DESIGN REVIEW RECOMMENDATION

DPD # 3019125

4528 44th Ave. SW
Seattle, WA 98116

PROJECT NAME:
44TH AVE SW STUDIOS

EDG PREFERRED OPTION

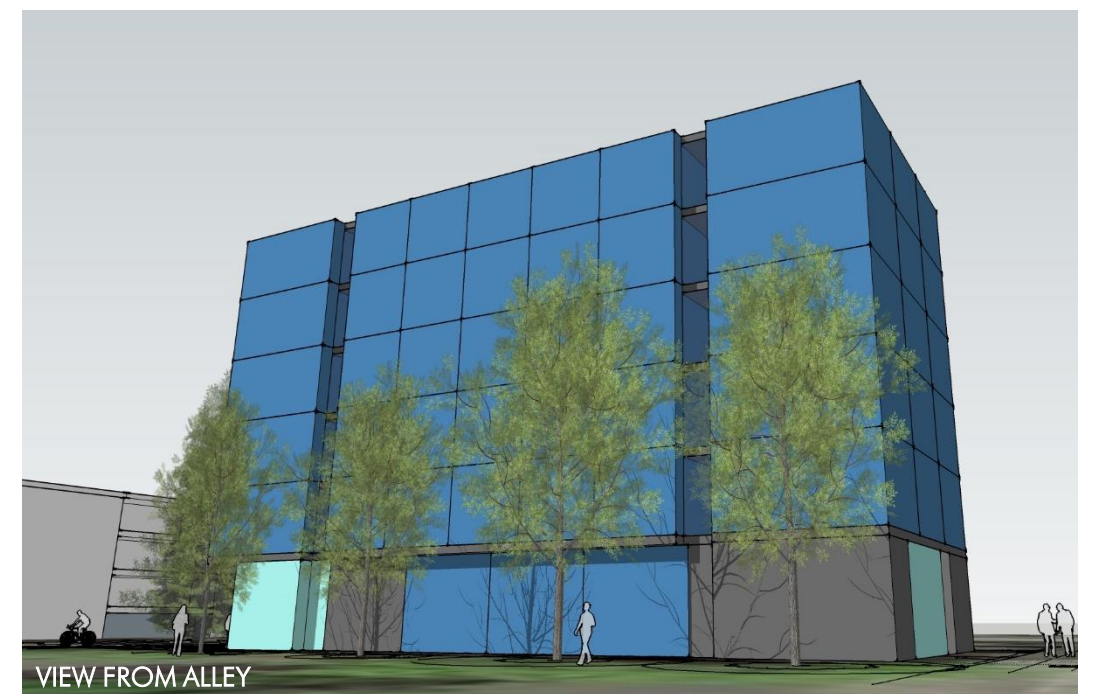
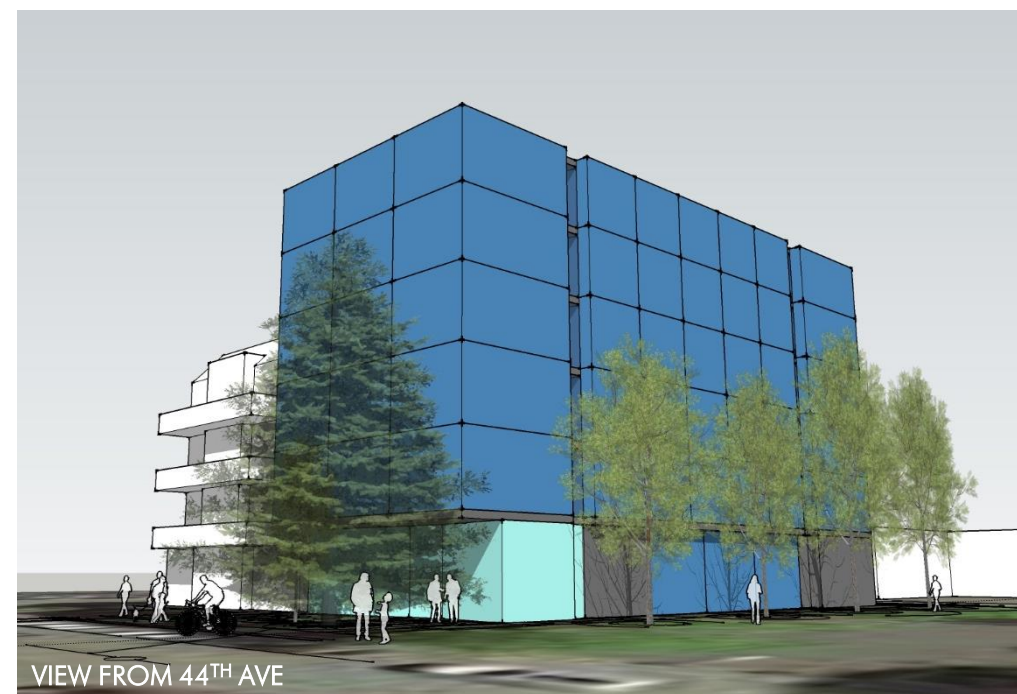
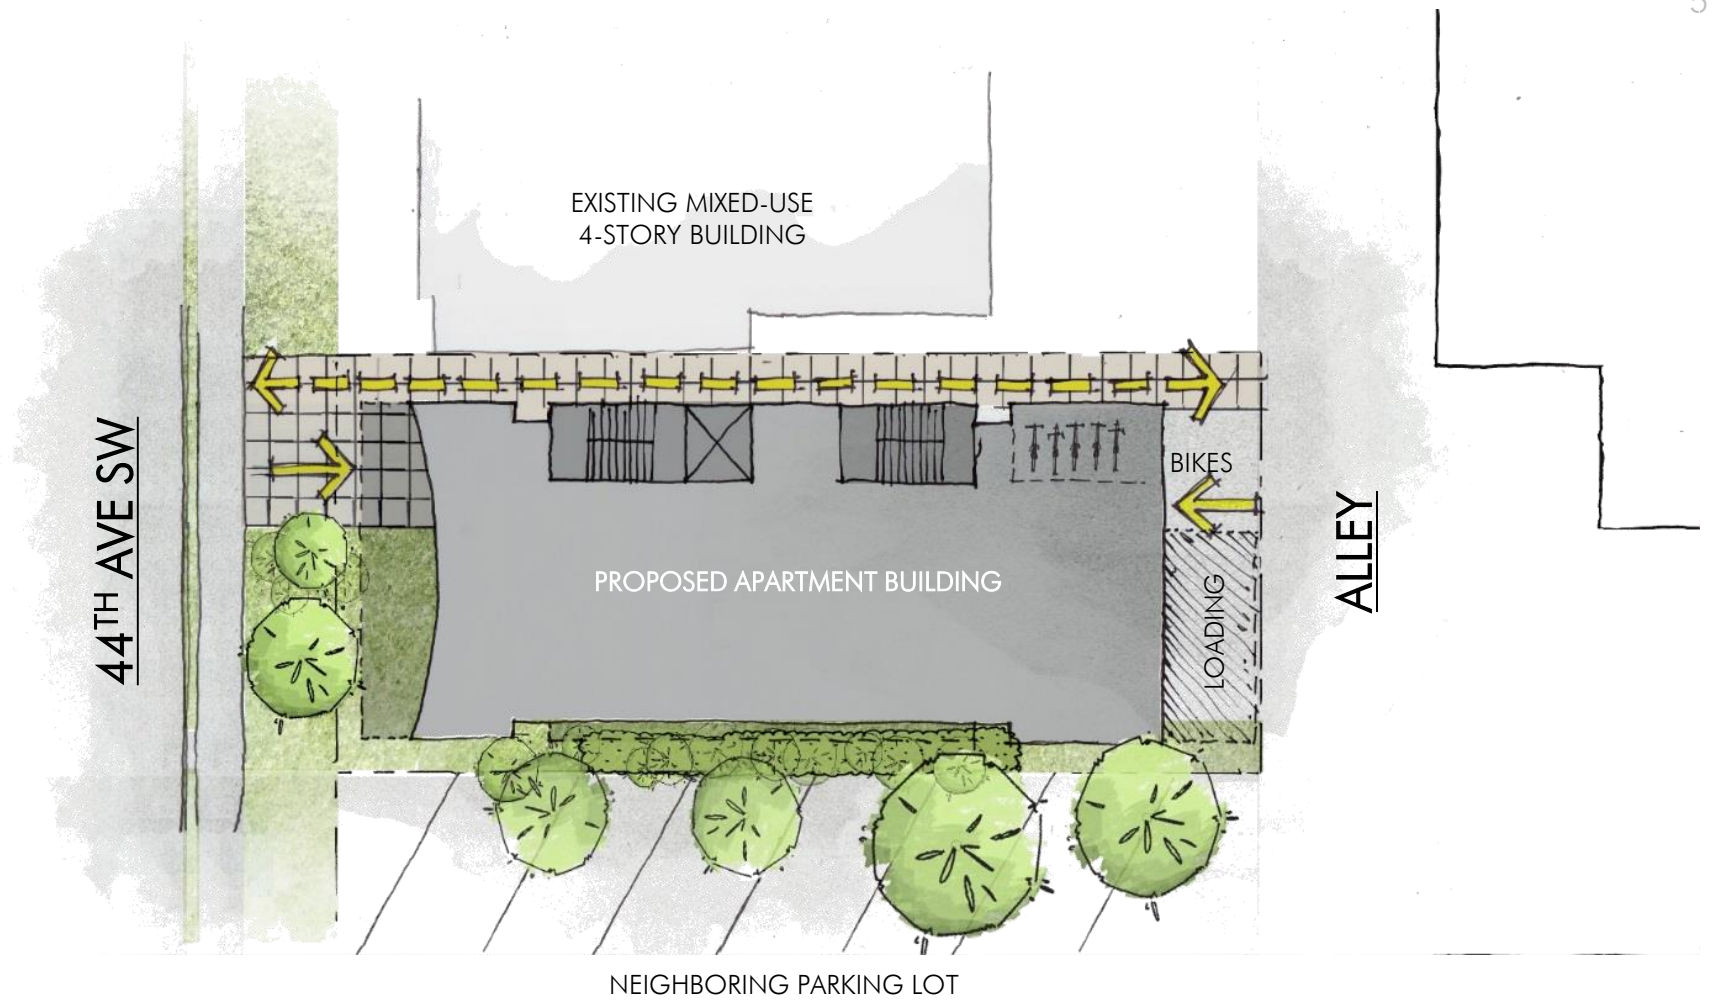
DESIGN REVIEW BOARD DIRECTION

- Further develop the proposed proportions and vertical form. Include more shaping of the façade, similar to the proposed angular west façade.
- Add breaks in the massing.
- Provide horizontal relief along the south façade.
- Shift building to the north to relocate the through-block pedestrian pathway to the south.
- Retain the arrangement of uses at the ground floor, specifically the lobby, amenity and adjacent open space along 44th.
- Shift the bike room to the southeast corner of the building.
- Retain location of vertical circulation at the north edge of the building.
- Use high quality materials.
- Include detailing (through materials or other means) to avoid blank facades and break up visual mass.
- Include secondary architectural details including pedestrian lighting, signage and specifically weather protection at both entries.

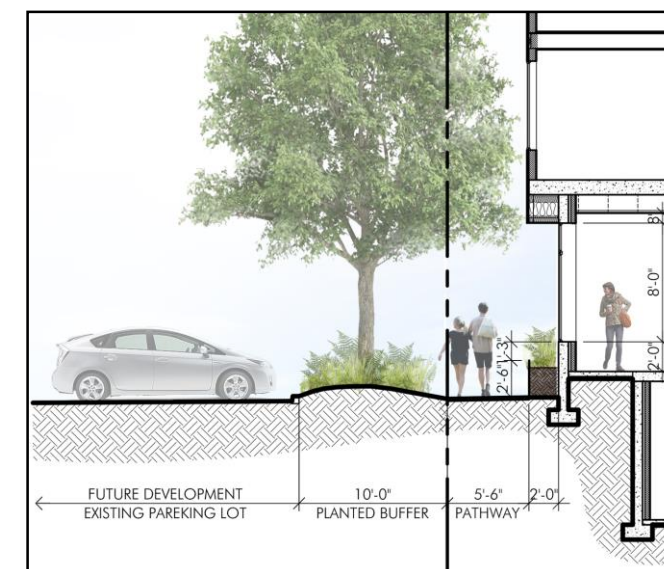
The Board supported the general arrangement and locations of the ground floor amenity spaces.

The Board supported the oversized bike storage space along the alley but asked the applicant to shift it to the southeast corner to maximize daylight to the space and better activate the alley portion of the building.

The location of the vertical circulation along the north portion of the building was supported for maintaining privacy for the existing building to the north while maximizing the daylighting and views of the proposed units. It was suggested that the circulation could be used to break up the massing at the upper levels.

The ground level amenity spaces have been further developed with large windows facing both the street and the pedestrian pathway along the south edge of the site.

The bicycle storage and repair room has been moved and is now prominently located at the southeastern corner of the building with large windows facing on the alley and pedestrian pathway.

Similar to the south elevation, the corridors for each floor are expressed and setback from the edge of the building, reading as vertical light shafts. The program requirements of the stair/elevator volume (vertical shafts for circulation) limit massing opportunities for breaking down the scale. We have taken a simplified approach to this volume by wrapping it in a tactile material (commercial grade horizontal lap siding) and a vertical grouping of windows at the elevator lobby of each floor.
